**METROPOLITAN GOVERNMENT OF NASHVILLE AND DAVIDSON COUNTY**

**STAFF RECOMMENDATION**  
**107 Lauderdale Rd.**  
**September 19, 2012**

**Application:** Partial demolition—existing rear porch; Demolition—accessory structure;  
New construction—addition and accessory structure;

**Description of Project:** Application is to demolish an existing rear porch, demolish an existing accessory structure, and construct a new rear addition and a new accessory structure. The project also involves expanding a second-story dormer.

SECOND FLOOR PLAN 1

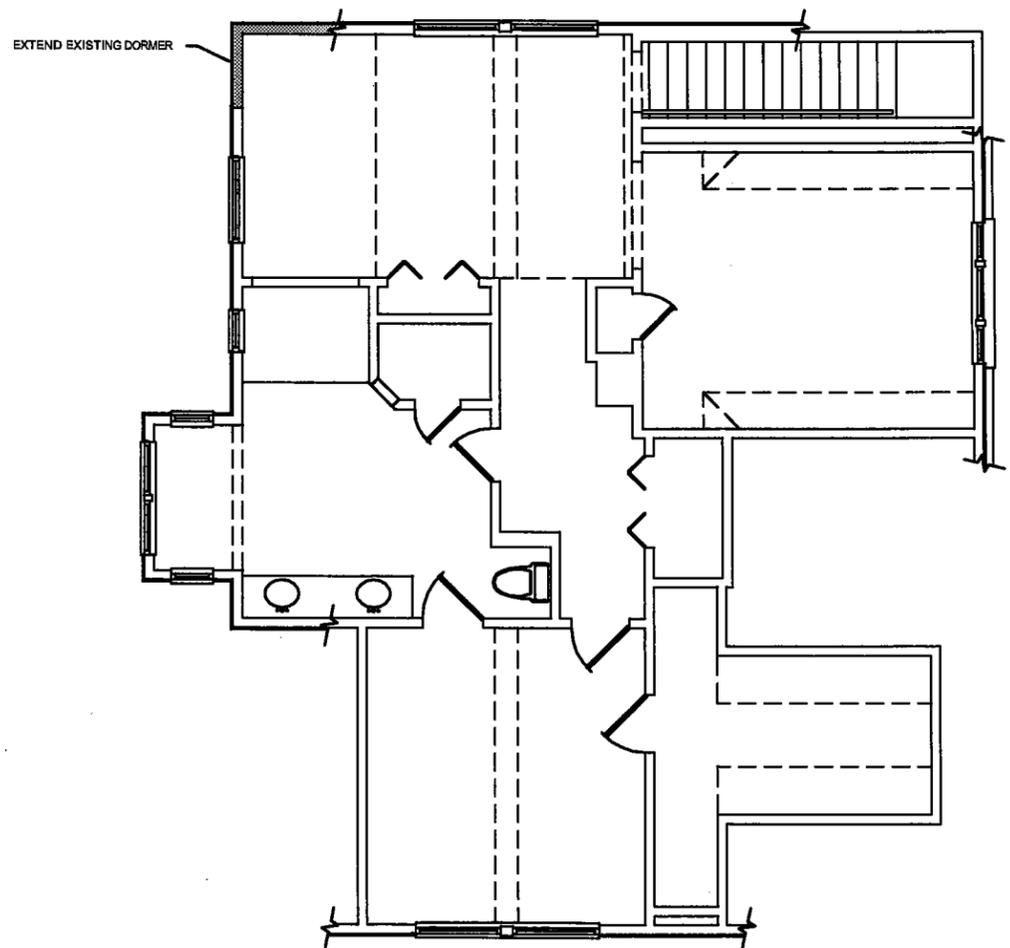
The application proposes to extend an existing rear dormer (see photo below). The dormer currently sits more than thirteen feet (13’) from the house’s left side wall and approximately three feet, nine inches (3’9”) from the house’s right side wall. The applicant proposes to extend the dormer so that it lines up with the house’s right side wall. However, the design guidelines state that rear dormers should be inset from a house’s side walls by a minimum of two feet (2’). Staff therefore asks that a condition of approval be that the dormer be extended a maximum of one foot, nine inches (1’9”) towards the house’s right side wall so that it is a minimum of two feet (2’) from the side wall.

With the condition that the extended rear dormer be inset a minimum of two feet from the side walls of the house, staff finds the addition’s roof pitches and forms and the extended dormer to meet Sections II.B.1.e. and II.B.2.a. of the *Cherokee Park Neighborhood Conservation Zoning Overlay: Handbook and Design Guidelines*.

1. The extended rear dormer be inset a minimum of two feet (2') from the side wall of the historic house.
2. A revised set of elevations showing the major measurements and heights of the house and the addition be submitted prior to permitting.
3. Staff approve the windows, doors, roof material and color, stone sample, and brick sample for both the addition and the accessory structure prior to purchase and installation of these materials.

LEFT SIDE ELEVATION 1

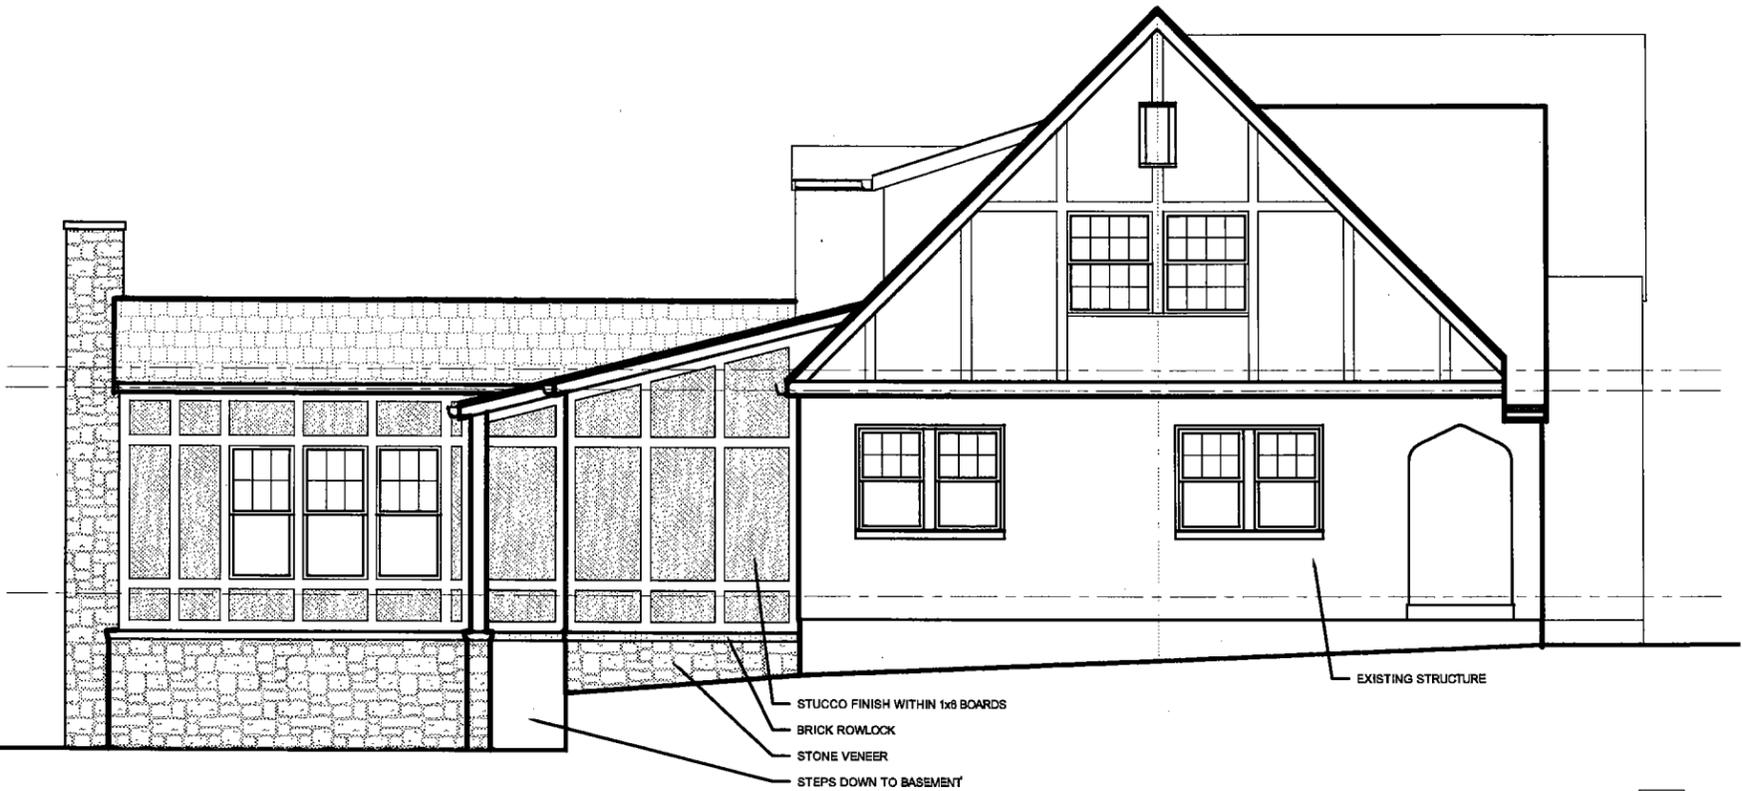
proportions for historic window openings. The largest expanse of wall space without a window or a door opening is on the left façade and is approximately thirteen feet, six inches (13'6") wide. Staff finds this expanse acceptable in this instance because it is located beyond the back wall of the historic house and it is inset from the side wall of the house, making it at most minimally visible from the street. Staff finds that the addition's proportion and rhythm of openings meet Sections II.B.1.g. and II.B.2.a. of the *Cherokee Park Neighborhood Conservation Zoning Overlay: Handbook and Design Guidelines*.
